INDEPENDENT REVIEW OF BASEMENT IMPACT ASSESSMENT

It is proposed to construct a deep basement extending rearwards from the existing house to house a private underground gym and swimming pool.

1. Basement Impact Assessment by Symmetrys , Ref: 21066-SYM-XX-XX-RP-S-0001-Rev D dated 2nd May 2023
2. Flood Risk Assessment and SUDS Report by Symmetrys , Ref: 21066-SYM-XX-XX-RP-C-0001-Rev A dated 3rd May 2023
3. Design and Access Statement by Crawford Partnership, dated March 2023

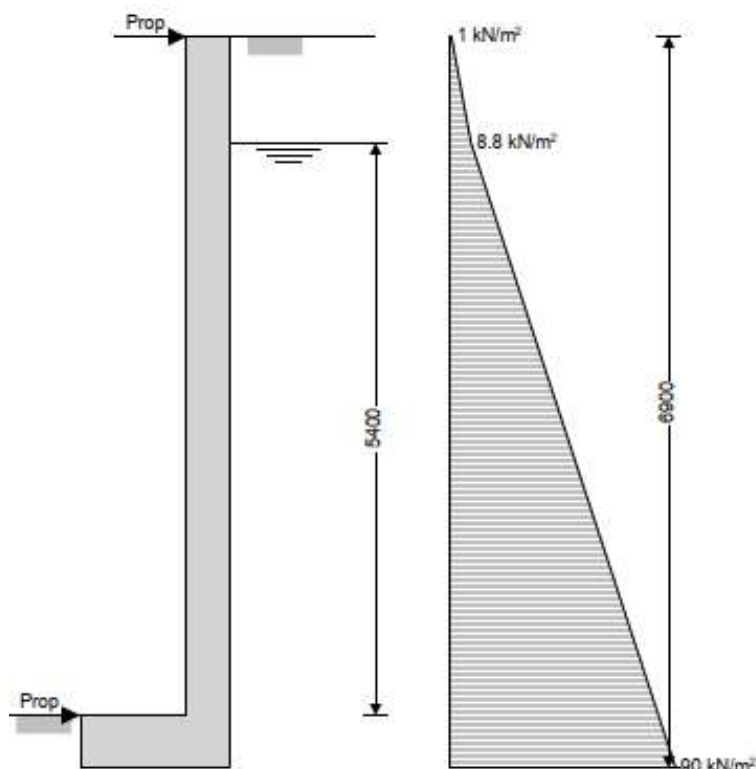
The BIA has not undertaken groundwater monitoring and has discarded this evidence of water noted in the borehole at 0.85m depth.

It is relevant to note that the water monitoring standpipe installed by SAS to a maximum depth of 5m will be of limited usefulness in assessing the risk of groundwater ingress to an excavation that is planned to extend to almost 7m depth. (see BIA applicants submitted retaining wall section below)

Proposed method statement/ suggested sequence of works

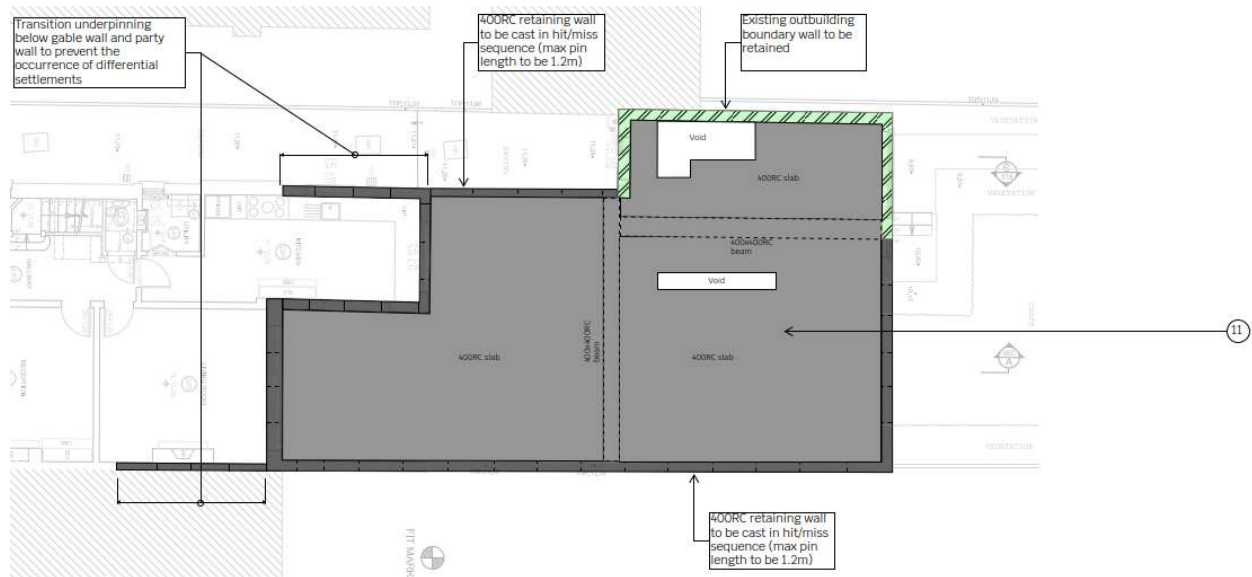
Given that there are piles shown on the drawings it is presumed that the second version is in error and the following discussion therefore relates to the first version. It is noted that this versions states that it should be read in conjunction with drawings 21066-SYM-XX-XX-SK-S-0201/0202/0203-REV P1. Given that this version is shown on drawings 21066-SYM-XX-XX-DR-S-0201/0202/0203-REV P1 this cross reference is presumed to also be in error.

However, if this first version is to be taken as any indication or assurance of the proposed basement construction methodology then it must be rejected. It is not a basement construction method statement. It is no more than a list.

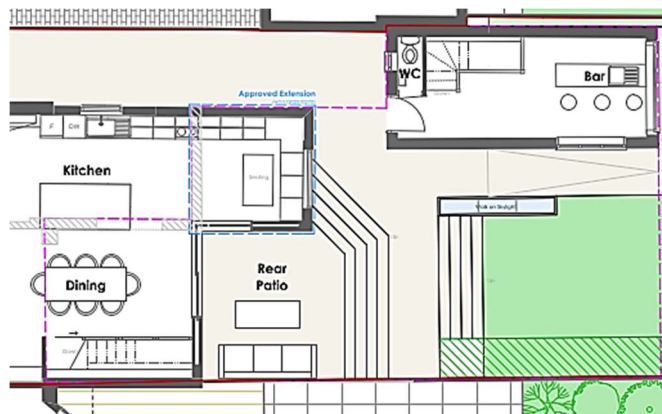
Despite being difficult to interpret in the absence of complete site sections and relevant drawings, it becomes apparent that the presented methodology and sequence is flawed. For example, only after excavation has proceeded down to basement level (Stage 7) is it proposed to cast the 400mm thick reinforced concrete slab at ground floor level (Stage 11) shown below.

However this 400mm thick slab will obviously block the proposed stairs shown on the ground floor plan shown below.

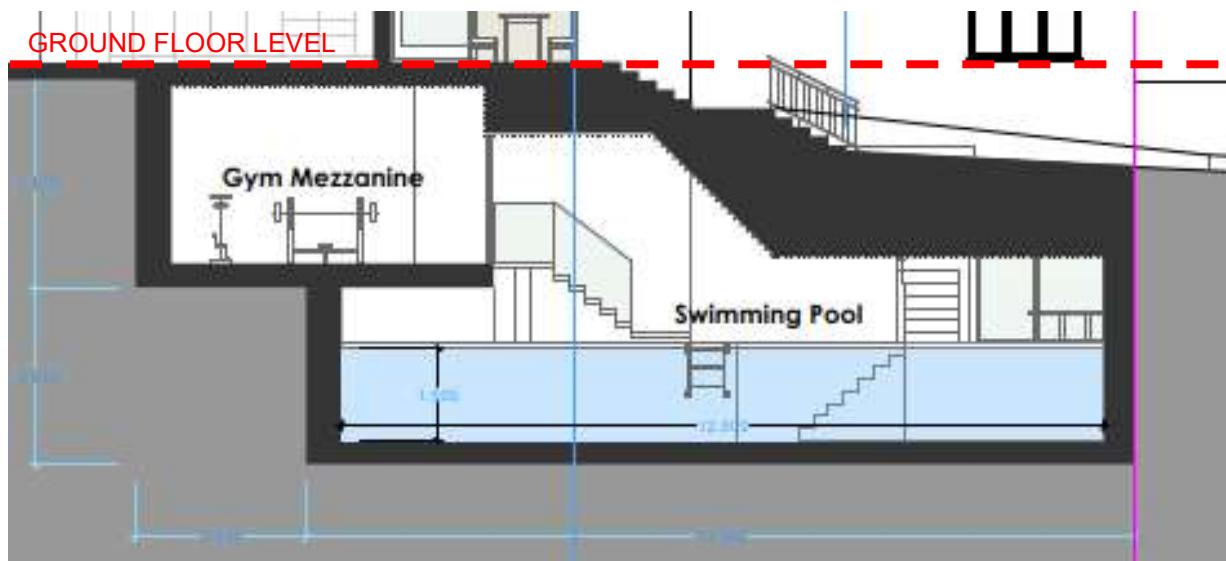
More importantly, it can be seen from the section on the next page that there can be no such slab at ground floor level as the roof of the basement will step down progressively.

In the absence of relevant temporary works sections there is absolutely no indication of how the western site boundary and the rear patio of No. 137 is supposed to be supported.

The drawings sequence indicates two stage underpinning beneath the party wall and adjacent excavation of the basement. This does not correlate with the plans, which suggest that the basement will not extend beneath the existing house.

Proposed plan

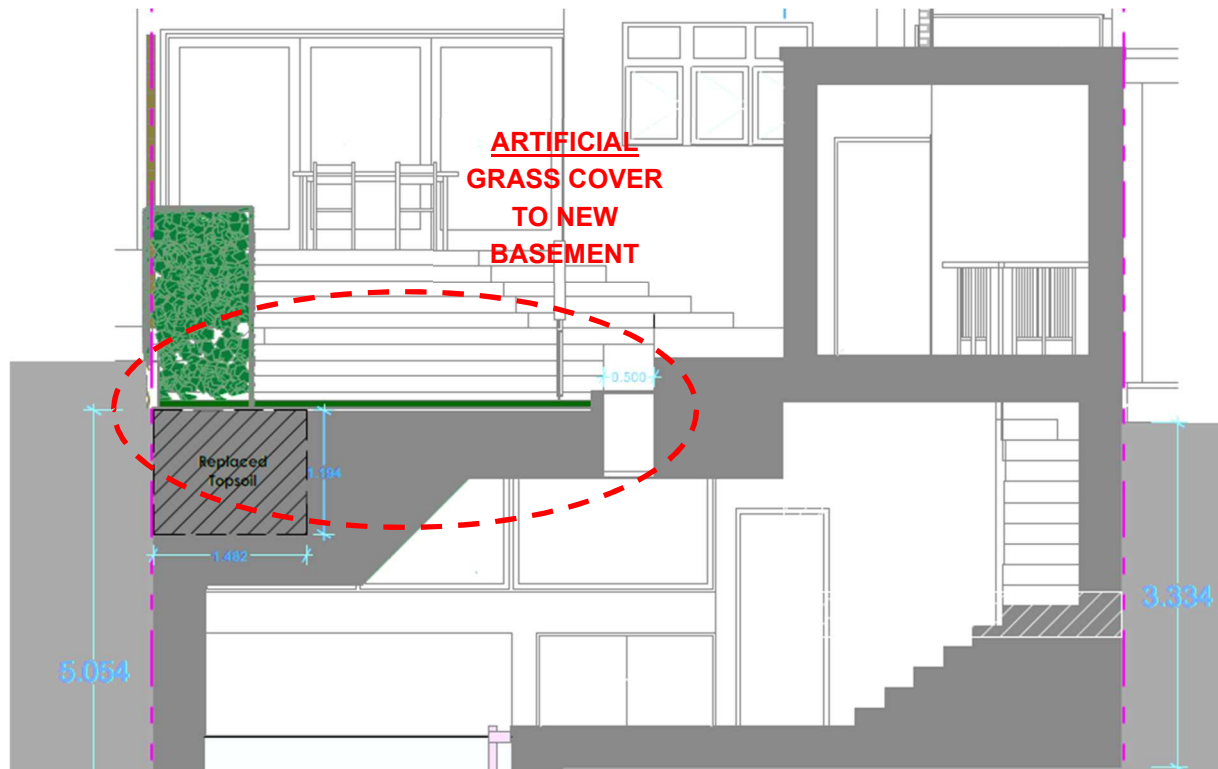
The architects design and access statement states that *"the existing garden will be fully planted and landscaped in order to provide an enhanced garden aspect to be enjoyed by the owners of No.139 Cranley Gardens alongside their neighbours."* However, the proposed plans clearly show the existing Astro turf pitch being retained and there being only a strip of topsoil positioned to support a hedge along the boundary with No. 137.

If the above drawing is incorrect and the basement is to be set 1m deeper in order to allow space for a restored garden above then this will require a rethink and re-design of the proposed stair layouts and of the proposed construction methodology.

The section above clearly shows that the full width of the property is to be excavated and replaced by the new basement. This will in effect cause the development to act as an impermeable dam to any water travelling from Cranley Road to the Cricket Ground, forcing it instead to travel down the road to the junction with Park Road, where it is understood street flooding occurred in 2021.

The site as presented in the submitted Lidar assessment (above) and as it actually is (below)

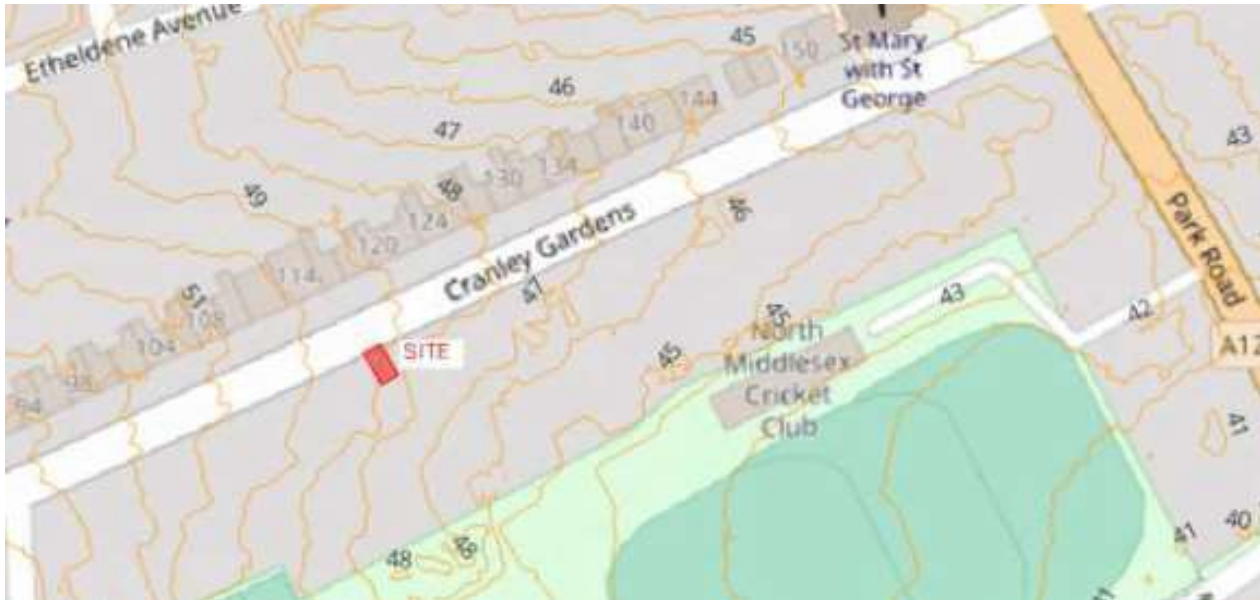
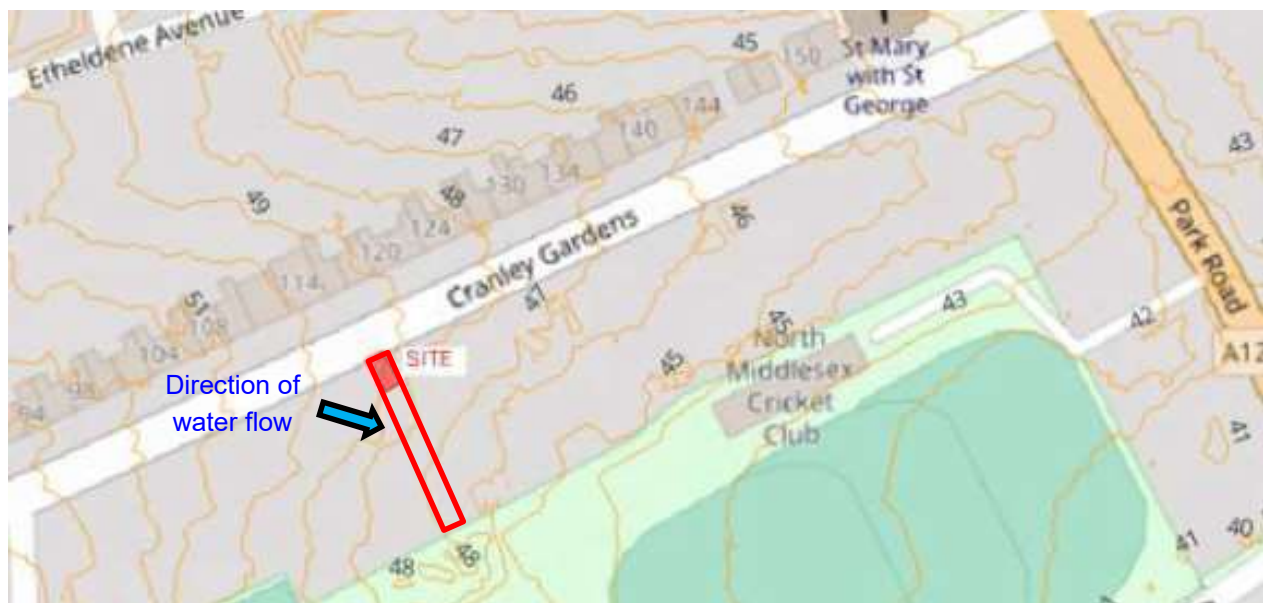
The SuDS report suggests the site to be a negligibly small area in the context of the problem area of overland flooding slope whereas the site is larger and may play a more important role in terms of hydrological impact.

It is apparent the basement will interrupt or interfere with the downslope flow of surface or near surface flow of water passing under the adjacent properties. This would inevitably affect the availability of water to the trees in the neighbouring garden to the east (No. 141) and would be expected to increase the risk of waterlogging to the rear garden of the property immediately to the west (No. 137).
